# **EPA Superfund Record of Decision:**

**Rock Hill Chemical Co.  
Rock Hill, SC  
6/27/1994**

**RECORD OF DECISION**  
**SUMMARY OF REMEDIAL ALTERNATIVE SELECTION**

**RUTLEDGE PROPERTY SUPERFUND SITE**

**Figure No. 3**

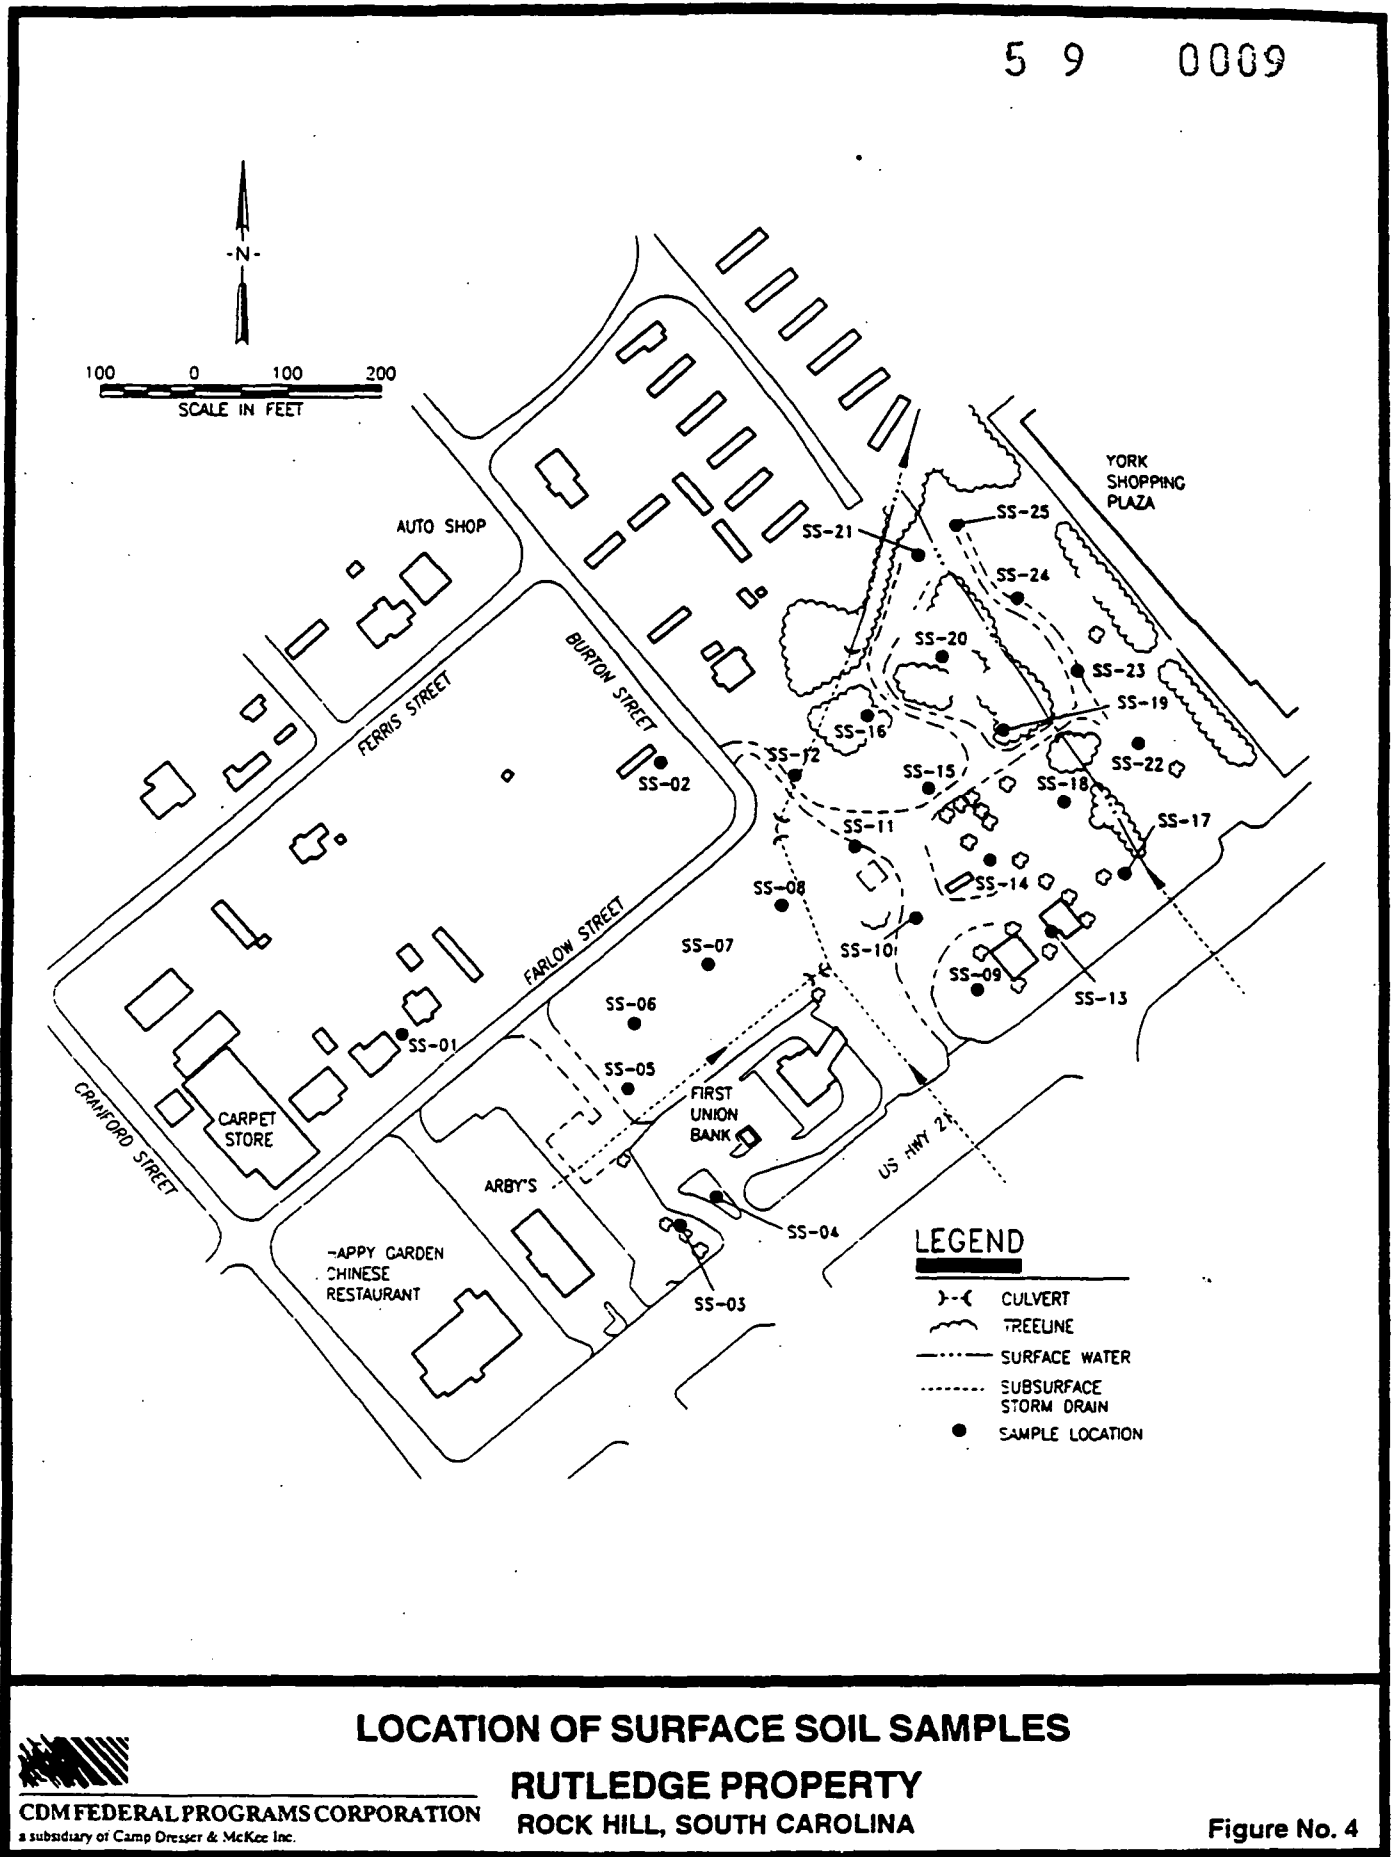
COMMENT: A written comment and one brought up at the public meeting concerned the fact that contaminants similar to site-related contaminants were detected in private wells PW-03 and PW-04. The written commentator felt the monitoring well network was extensive and sufficient to determine that the contaminants were not site related. The commentator at the public meeting was not sure that this was true, and that possible further characterization was needed, since the deepest monitoring wells at the site may not have been as deep as the private wells.

RESPONSE: EPA stated in the public meeting that during the remedial design, the depth of PW-04 would be determined. Also during the remedial design, the level of the water table in the well will be measured. This will be compared with the water levels of the monitoring wells on-site, to determine if the groundwater would flow from the Site to the private well or from the direction of the private well toward the Site. If after this, it is determined by EPA that a potential migration pathway from the Site to PW-04 may exist, additional monitoring well(s) may be installed.
